Final Environmental Assessment
Utah Coal and Biomass Fueled Pilot Plant
Kanab, Utah

DOE/EA-1870

December 2011

U.S. Department of Energy
National Energy Technology Laboratory

Figure 2-3. Conceptual Drawing of Pilot Plant

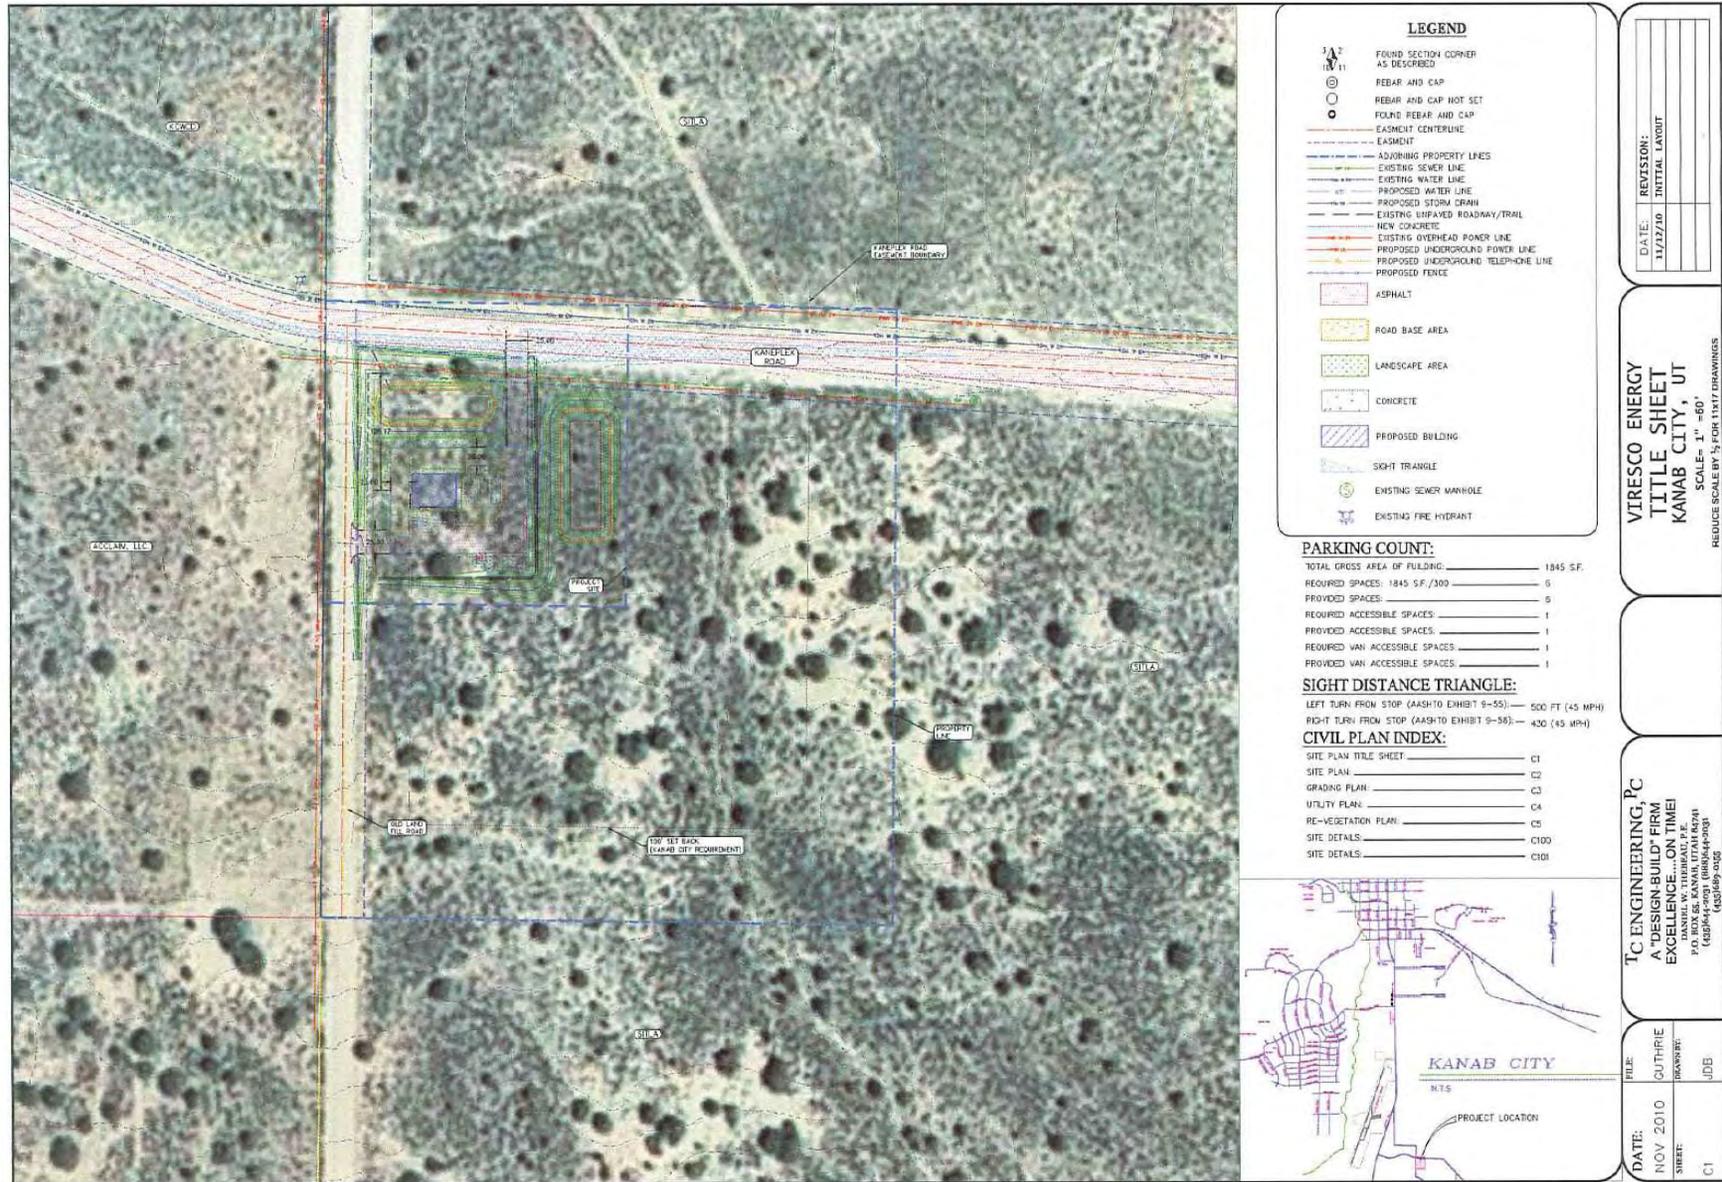
pond; no evaporation pond is discernable in Figure 2-3. Please explain what is meant by "returned to the environment". Would this effluent truly be left to evaporate in a pond?

Section 2.7.2 and Figure 2-4 cover Viresco's operational plans as implemented under the proposed action (30-day); the evaporation pond discussed in Section 5.2 refers to one of Viresco's options in handling

Figure 2-4. Utah Coal and Biomass Fueled Pilot Plant Processes

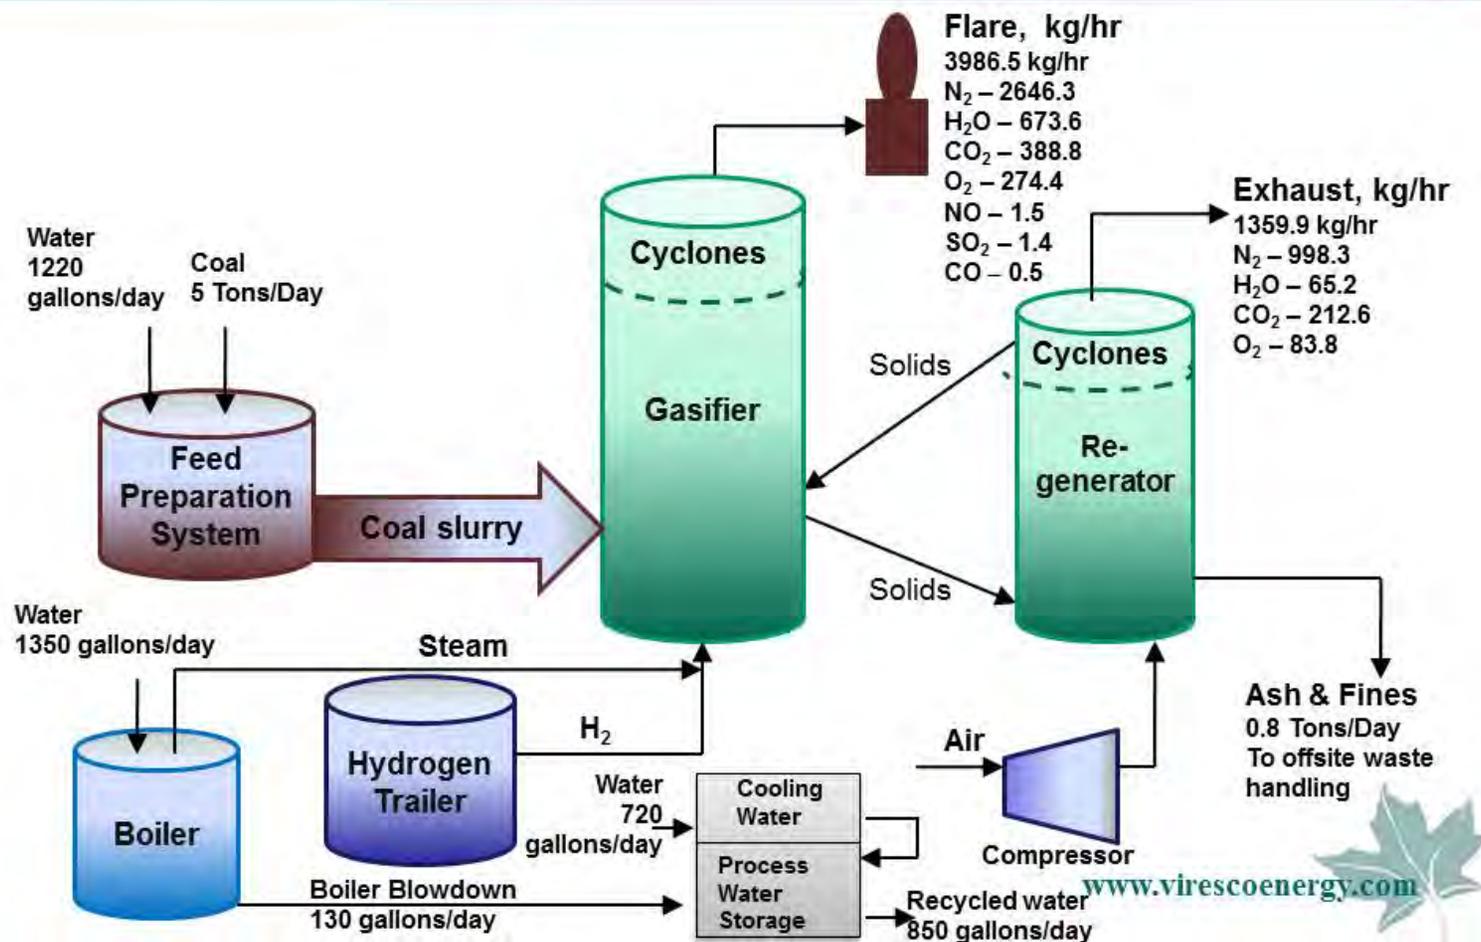
- 6-03** Figure 2-4 shows that 100% of the exhaust from the cyclone re-generator is nitrogen, water, carbon dioxide and oxygen. Do you really believe there won't be any toxic compounds, methane gas, or other substances released into the air?

- 15-11 P 15 par3:
Information about potable water use contradicts itself and seems intentionally misleading within the table and in the illustration (Figure 2-4) and paragraphs on p 15. Separating potable vs. non-potable water makes no sense since the paragraph states that ALL water will be supplied by Kanab's potable water system:
 Process water ... 1,270 gpd for a total of 38,100 gallons for 30 days of operation.
 (Figure 2-4 shows 1320 gpd.)The daily potable water demand by the Pilot Plant when it is operational would be limited to the needs of a workforce of 9 employees at 250 gpd for a total of 7,500 gallons for 30 days of operation. Both the process water and the potable water would be supplied by the City of Kanab's potable water system. The total daily rate of potable water use (1,520 gpd) (according to the diagram this figure should be 1370) represents 0.03 percent of the existing wells and spring capacity that supply the City of Kanab's potable water system.

- 48-03** 1. On page 16, section 2.7.2 and page 17, Figure 2.4 include an air compressor for the regenerator. This compressor is not addressed in the emission calculations. Please verify that this compressor is electrically-powered and not run on hydrogen or propane.

"Most notable emission would be of carbon monoxide and is estimated to be less than 16 tons for 130 days of operation." Yet Per figure 2-4, Flare emits 9183 lbs/hr= 5 tons/hr!

Total process water demand (non-potable use) for the Pilot Plant under the proposed action would be approximately 3,290 gpd, potentially all of it supplied from the City of Kanab. It is anticipated that up to 850 gpd would come from recycled water from other plant processes, which could reduce the process water demand to 2,440 gpd. Additionally, it is estimated that employees of the facility would use 250 gpd of the City's water (potable water use). Section 2.7, including Table 2.7-1 and Figure 2-4, has been revised to clarify water demand and source of the water supply.

Section 2.7.2 and Figure 2-4 cover Viresco's operational plans as implemented under the proposed action (30-day); Section 2.8 discusses operational plans considered under the connected action (130-day maximum). See response to comment number 39-04 regarding the statement "returned to the environment."
